Bulletin No.: 10-06-01-008J

Service Bulletin

Subject: Engine Oil Consumption on Aluminum Block/Iron Block Engines with Active Fuel Management (AFM) (Install AFM Oil Deflector and Clean Carbon from Cylinder and/or Install Updated Valve Cover)

2740641

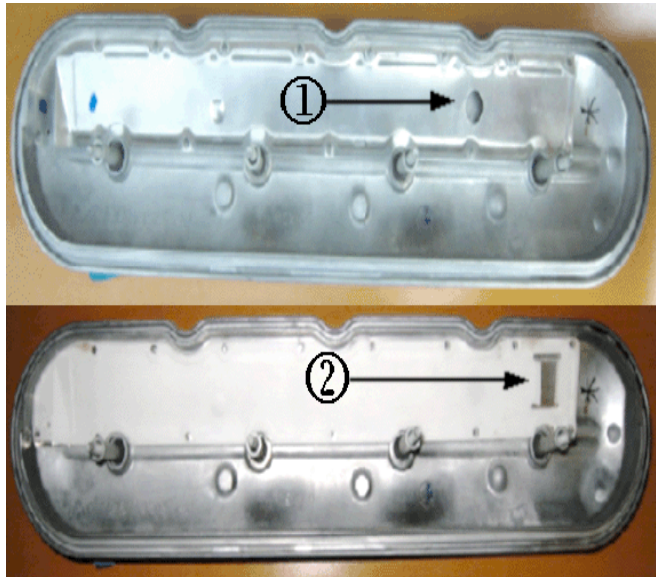
Aluminum or Cast Iron Block - Oil in Intake Manifold - Install Updated Valve Cover on All Models Built Prior to February 1, 2011

PCV pullover or an overactive lifter can cause oil to be pulled through the PCV system even at low vehicle mileage. A correctly functioning PCV system will only leave a film of oil in the intake manifold. Inspect the intake manifold to see if there is any oil puddling in the bottom. If there is you will need to replace the left valve cover. Two new left rocker arm covers have been released for trucks and vans. Technicians should replace the left rocker arm cover with GM P/N 12570427 for 2007-2008 or GM P/N 12642655 for 2009-2011. Refer to the Parts Information below for the Camaro. This rocker arm cover has a relocated PCV drain hole that prevents oil from entering the intake manifold. Refer to Valve Rocker Arm Cover Replacement - Left Side in SI.

Note: These rocker covers are for specific years. The PCV orifice is different for each. The correct cover must be used or an SES light may set.

1) Old Design

2) New Design

2474205

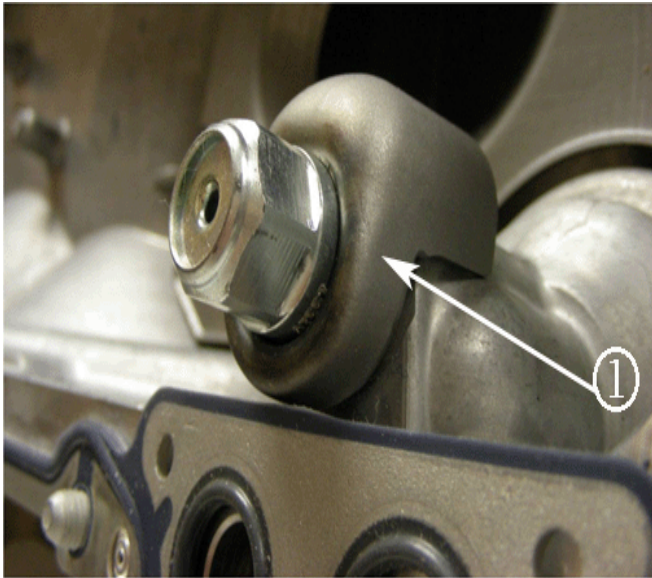
4. Remove the AFM valve (1).
